Re: ¹⁵²²5022 SW Blackstone Place
Lot 131, Napa Valley
Lee's Summit Permit #2017-1140

STRUCTURAL DESIGN REVIEW

PROJECT: 5022 SW Blackstone Place
Lot 131, Napa Valley

SLAB SUPPORT LAYOUT
NOT TO SCALE

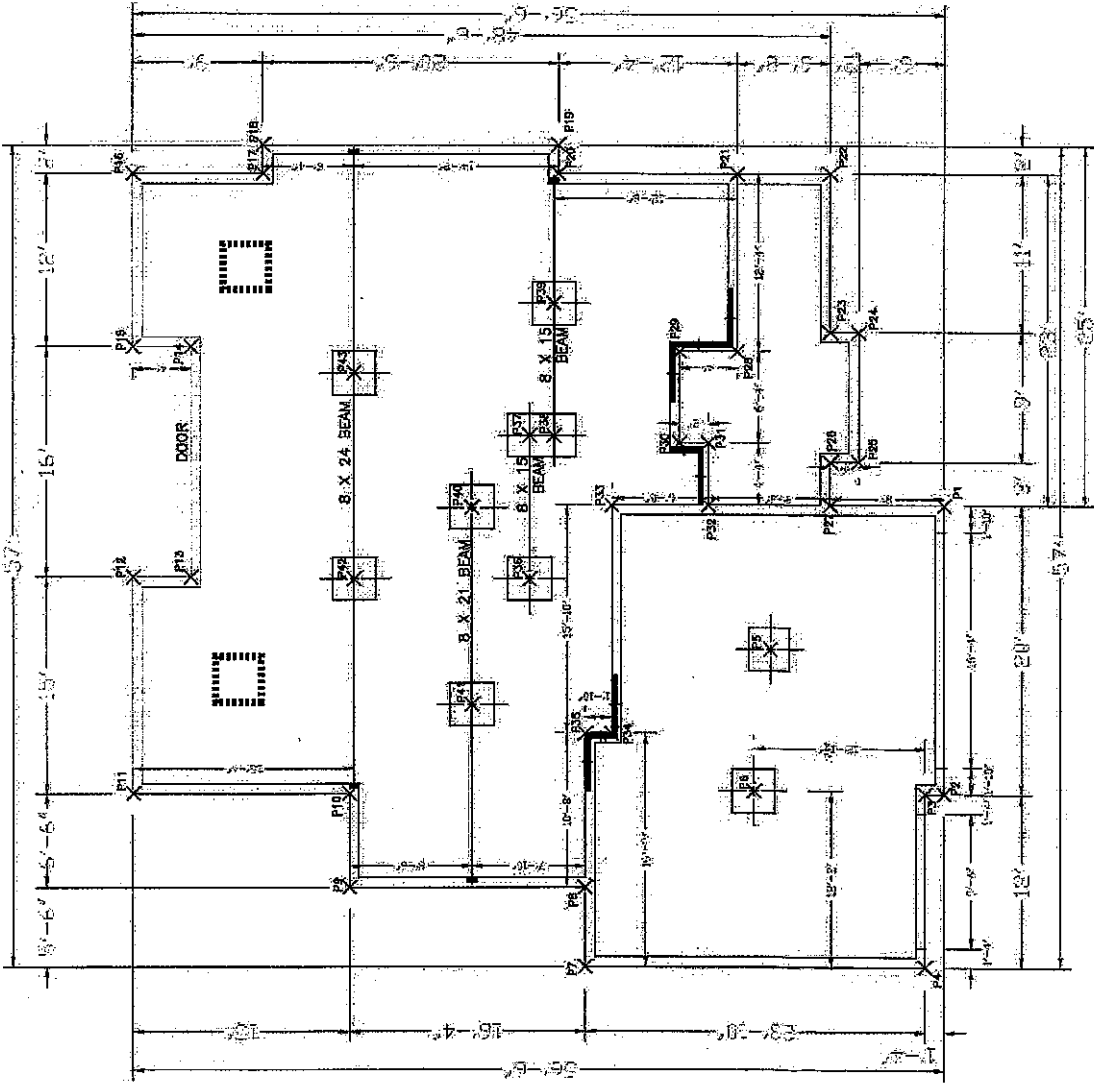
- Add (2) 36"x36" slab support pads per the attached layout. Reinforce with (4) #4 bars each way.
- Place 5" concrete slab w/ #4 bars at 12" o.c. each-way on 1-1/2" chairs.

- Add (4) 10'-0" long #4 bars each-way over the column pads and slab support piers. Place with 1" to 1-1/2" slab top cover (3" chairs). See attached slab details for clarity.
- The perimeter of the slab shall bear on the foundation as follows:
 - Minimum 3" keyway or footing, OR
 - Drill 5" deep and pin to foundation with #4 bars at 12" on center.
